**AGENDA
TECHNICAL REVIEW COMMITTEE
REGULAR MEETING
JANUARY 13, 2022
10:00 AM
CITY HALL COMMISSION CHAMBERS
204 ASH STREET
FERNANDINA BEACH, FL 32034**

- 6. NEW BUSINESS**
 - 6.1 SPR 2021-0014: Halff Associates, Inc., 59 S. Fletcher Ave., Construction of 10 individual hotel villas, office building and pool amenity.

- 6.2 SPR 2021-0015: Halff Associates, Inc., 87 S. Fletcher Ave., Construction of 10 individual hotel villas and office building.
 - 6.3 SPR 2021-0016: Nick Gillette with Gillette & Associates, S 13th Street - Construction of a group residential project with parking lot and dry retention.

CIVIL AND LANDSCAPE PERMIT PLANS
FOR
AMELIA ISLAND RENTALS

CONTRACT #AMELIA ISLAND
DRAWN : DG
CHECKED : MR
DATE : 12/8/2021
TOTAL A/S : 333 SQ FT
SCALE : 1/2", 1/16"=1'-0"
SHEET NO.
FP-1
PAGE NO.
2 OF 2

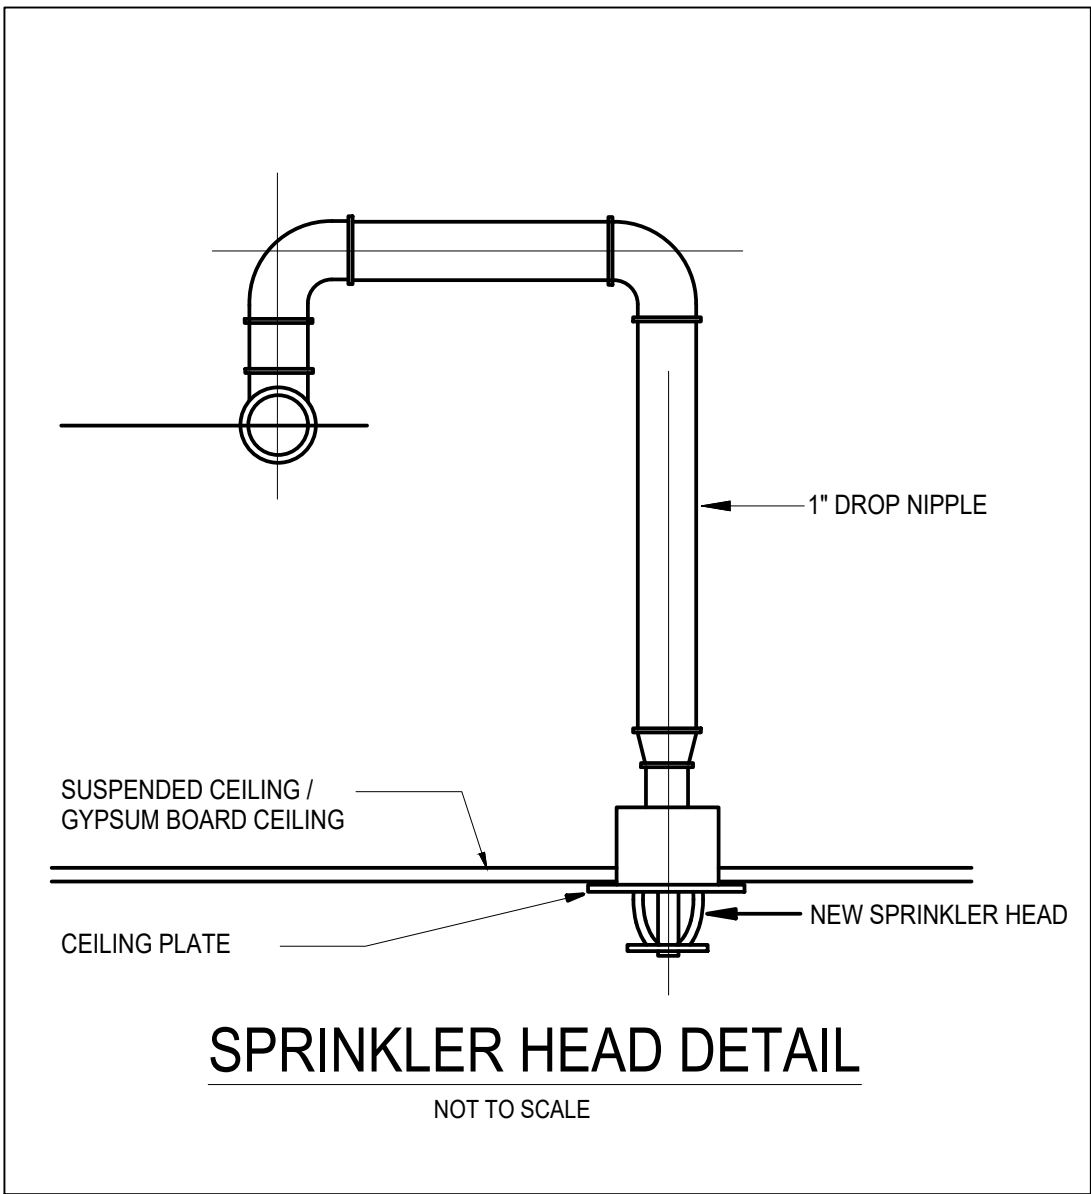
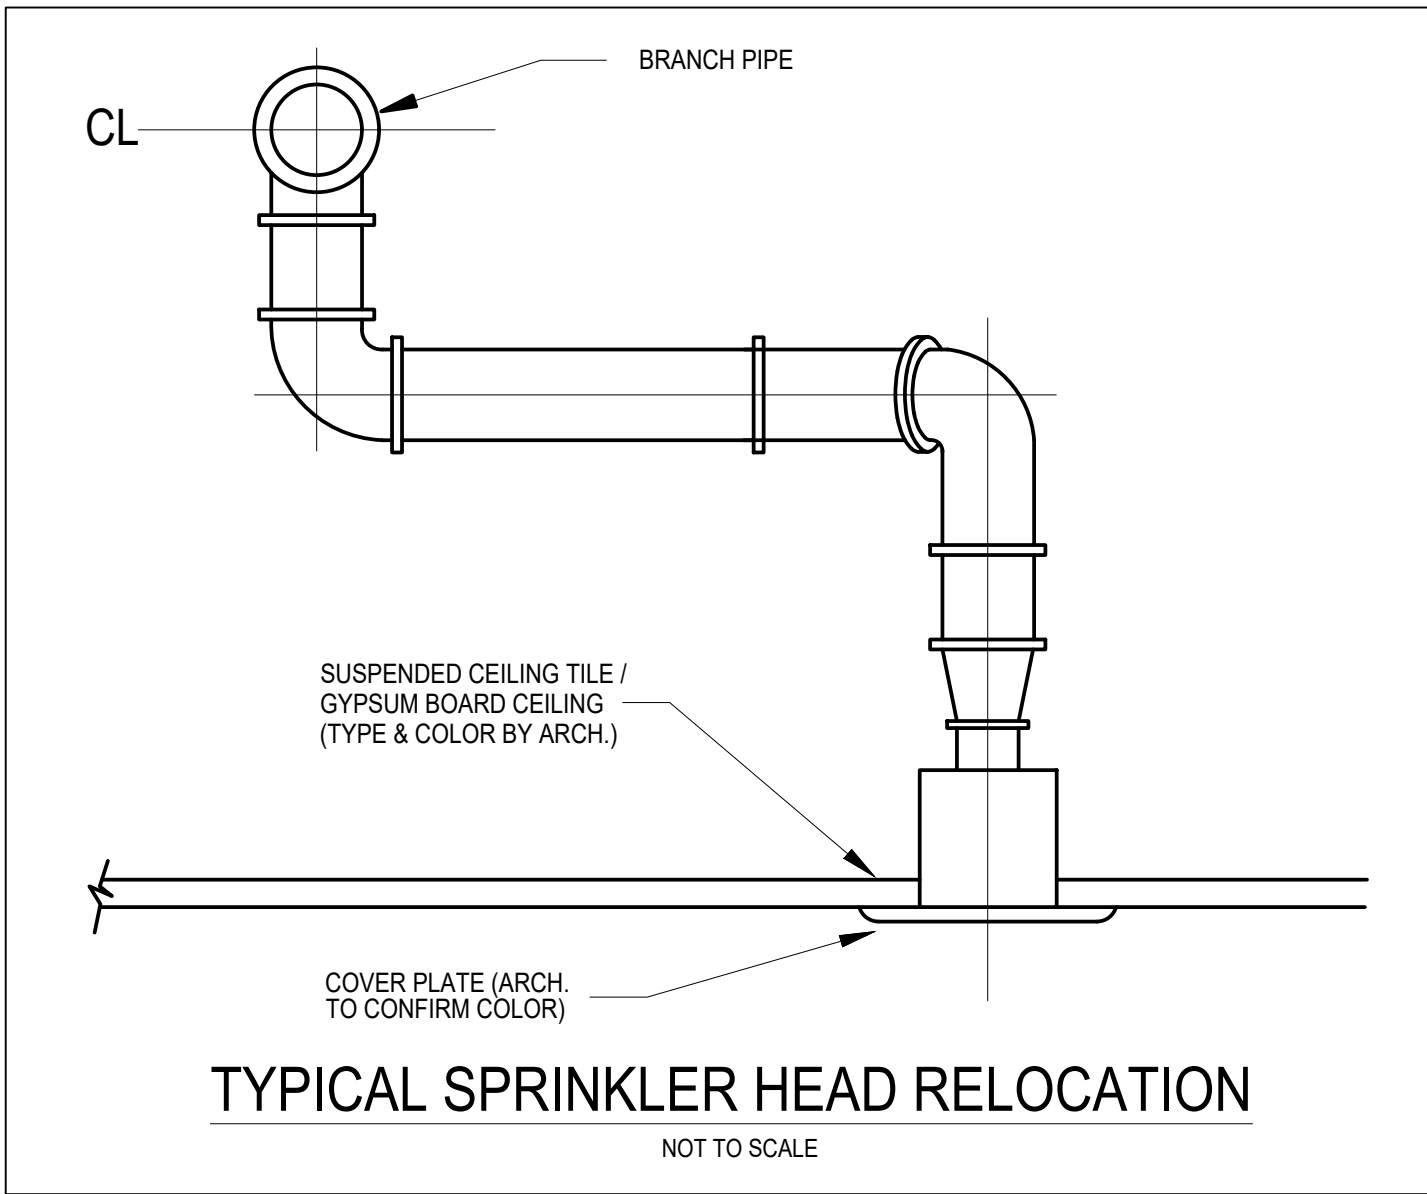
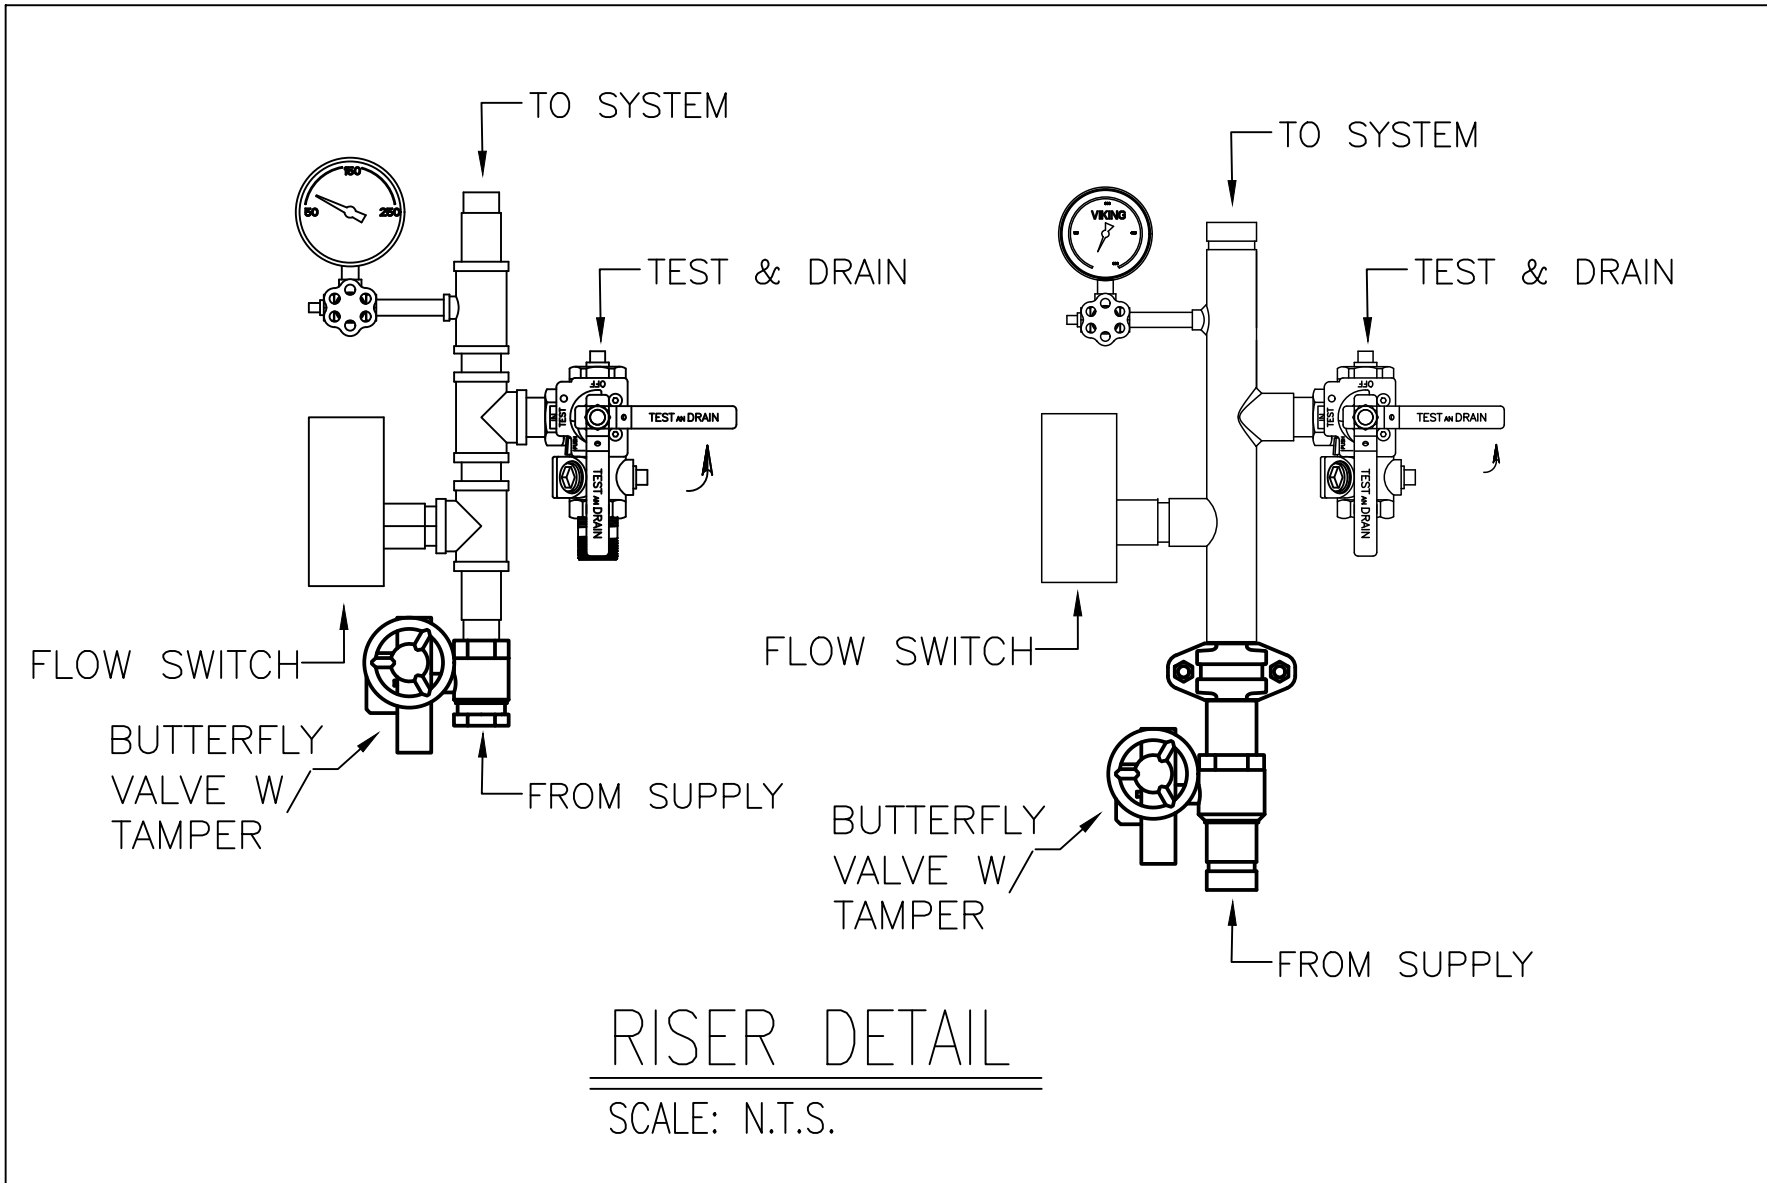
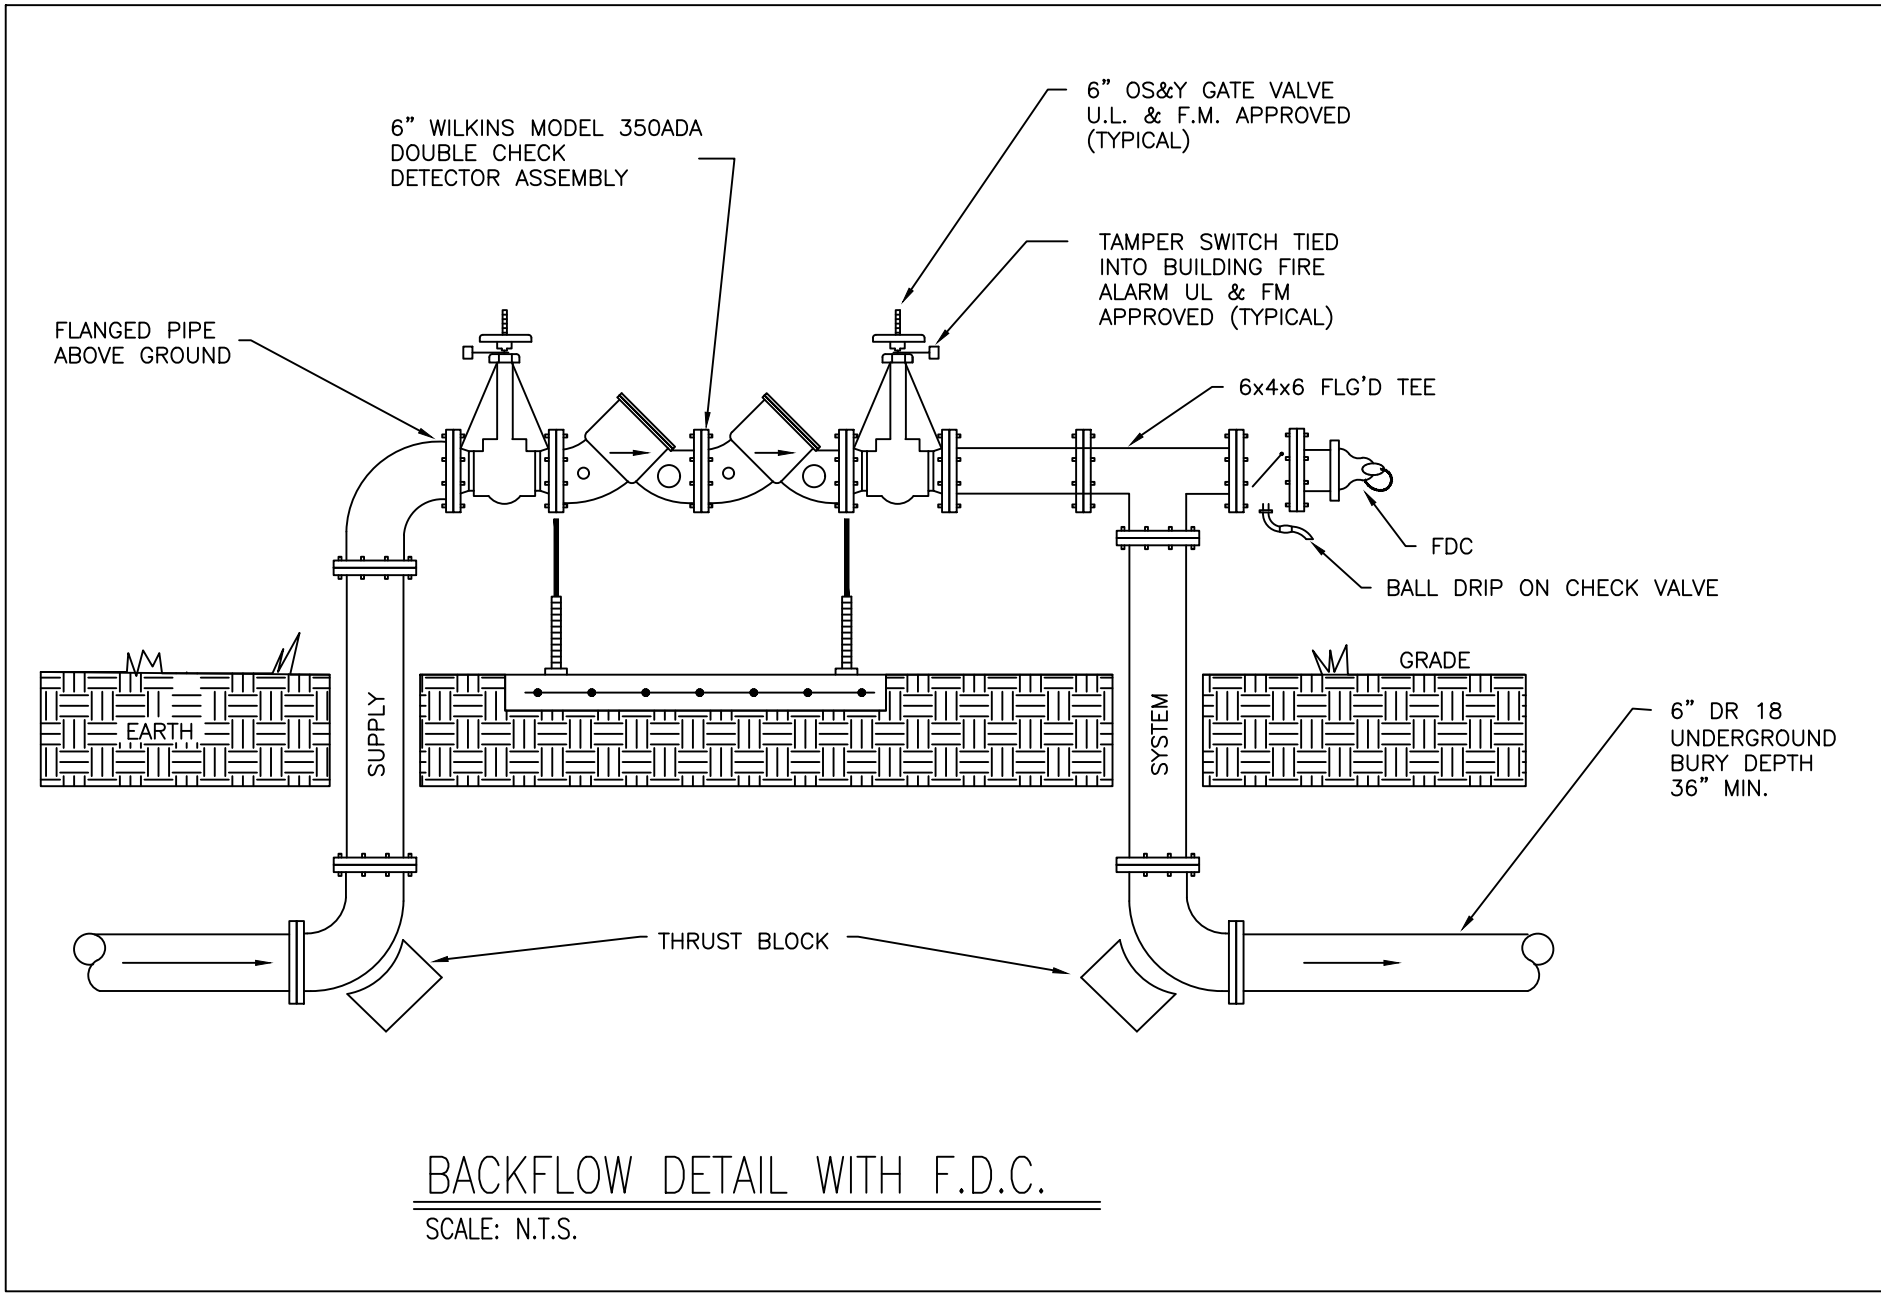
- Fire Sprinklers - Sheet # FP-1 - Due to keeping the lots separate, there should be two separate sprinkler systems, one for each property.
